**PLANNED UNIT DEVELOPMENT
& SUBDIVISION STAFF REPORT****Date: October 3, 2013****DEVELOPMENT NAME**

Longleaf Gates Subdivision, Phase Two

Planned Unit Development Approval to allow a private street subdivision, and Subdivision approval to create 61 legal lots of record from an existing metes and bounds parcel.

SITE PLAN

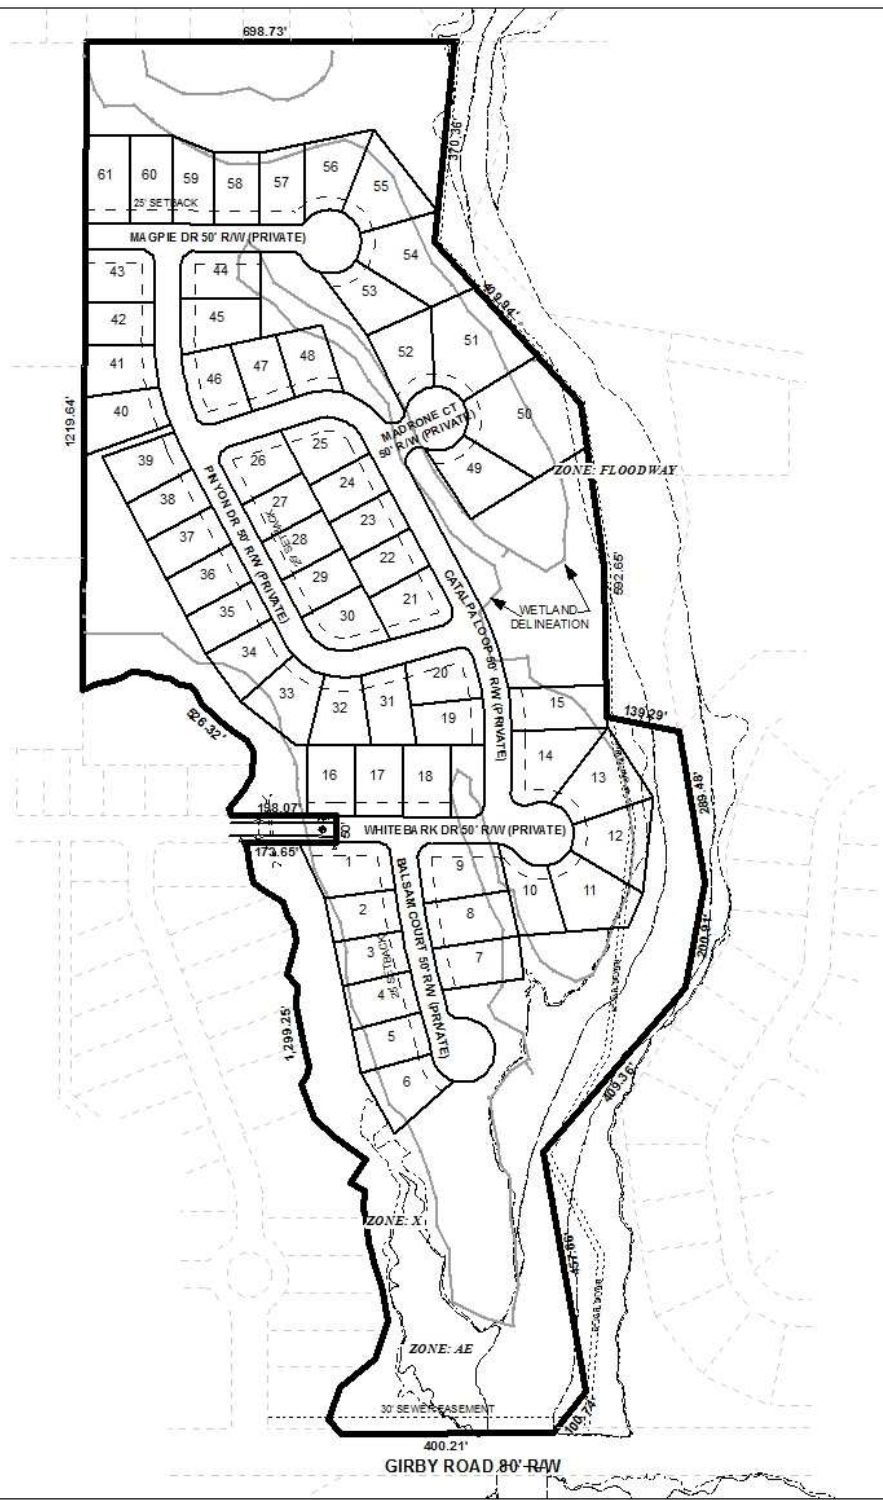
The proposed lots, as depicted, meet the minimum size and frontage requirements as regulated by the Subdivision Regulations. The proposed 25' minimum building setback line is depicted and should also be shown on the Final Plat, if approved. Each lot is labeled with its size in square feet and acres and this, too, should also be shown on the Final Plat, or a table should be furnished on the Final Plat providing the same information, if approved. As the area containing the proposed lots is zoned R-2, a note should be required on the Final Plat stating that each lot is limited to 40% maximum site coverage by all structures.

A note on the plat indicates that a 10' drainage and utility easement is dedicated along the front of all lots and along the side of lot lines abutting a right-of-way. Other lots are indicated to have an easement crossing the lots. Although the 25' minimum building setback line would negate the construction of any structure within the dedicated 10' easement within the setback, a note should be required on the Final Plat stating that no structure may be constructed within any easements.

The site has frontage on Girby Road, a component of the Major Street Plan with a planned 100' right-of-way. As the plat indicates a current right-of-way width varying from 80' to 90' along the Girby Road frontage, dedication would be required to provide 50' from the centerline of Girby Road. Revision of the labeled size of the Southern common area may be necessary due to the dedication. Proposed streets within the subdivision are indicated to have a compliant 50' right-of-way, and cul-de-sacs to have a compliant 60' radius as required by Section V.B.14. of the Subdivision Regulations for closed-end streets without a central median. As a means of access control, a note should be required on the Final Plat stating that each lot and common area

is limited to one curb cut, with the size, location and design to be approved by Traffic Engineering and conform to AASHTO standards. A note should also be required on the Final Plat stating that the Southern common area is denied direct access to Girby Road.

As all streets within the subdivision are to be private streets, the development of such should be in compliance with Section VIII of the Subdivision Regulations pertaining to private streets. Section VIII.E.1.a. does not allow private streets to serve adjacent properties, and it appears that the street stub in the Northwest portion appears to serve property not owned by the applicant. The 2009 approval conditioned additional street-stub connections will be required to adjacent public streets and landlocked properties (for emergency access only). Therefore, this stub should be replaced by a compliant 60' radius cul-de-sac with a shortened street stub labeled as "emergency access only" leading to the vacant property to the West. As on the plat, the streets should be labeled as "Private Street" on the Final Plat. A note would be required on the Final Plat stating that maintenance of the private streets is the responsibility of the property owners. And a note should be required on the Final Plat stating that if the private streets are not constructed and maintained to the appropriate City standard, and ultimately dedicated for public use and maintenance, 100 percent of the cost of the improvements required to bring the street up to the prevailing standards shall be assessed to the property owners at the time the private streets are dedicated, with the assessment running with the land to any subsequent property owners.

A large portion of the site is indicated to be common areas. The area adjacent to the East side of Lot 18 is not identified, but a telephone conversation with the engineer indicates this is to also be a common area; therefore, the plat should be revised to label this area as such with its size in square feet and acreage. A note should be required on the Final Plat stating that the maintenance of the common areas (detention areas) is the responsibility of the property owners.

- 1) illustration of the required dedication along Girby Road to provide 50' from the centerline;
- 2) revision of the labeled size of the Southern common area following the required dedication along Girby Road;
- 3) revision of the plat to label the area adjacent to the East of Lot 18 as a common area and also labeled with its size in square feet and acreage;
- 4) revision of the plat to indicate a compliant 60' radius cul-de-sac instead of a street-stub at the West terminus of Magpie Drive, with a shortened street-sub off it labeled "emergency access only" leading to the vacant property to the West.

- 1) illustration of the required dedication along Girby Road to provide 50' from the centerline;
- 2) revision of the labeled size of the Southern common area following the required dedication along Girby Road;
- 3) revision of the site plan to label the area adjacent to the East of Lot 18 as a common area and also labeled with its size in square feet and acreage;
- 4) revision of the site plan to indicate a compliant 60' radius cul-de-sac instead of a street-stub at the West terminus of Magpie Drive, with a shortened street-sub off it labeled "emergency access only" leading to the vacant property to the West.
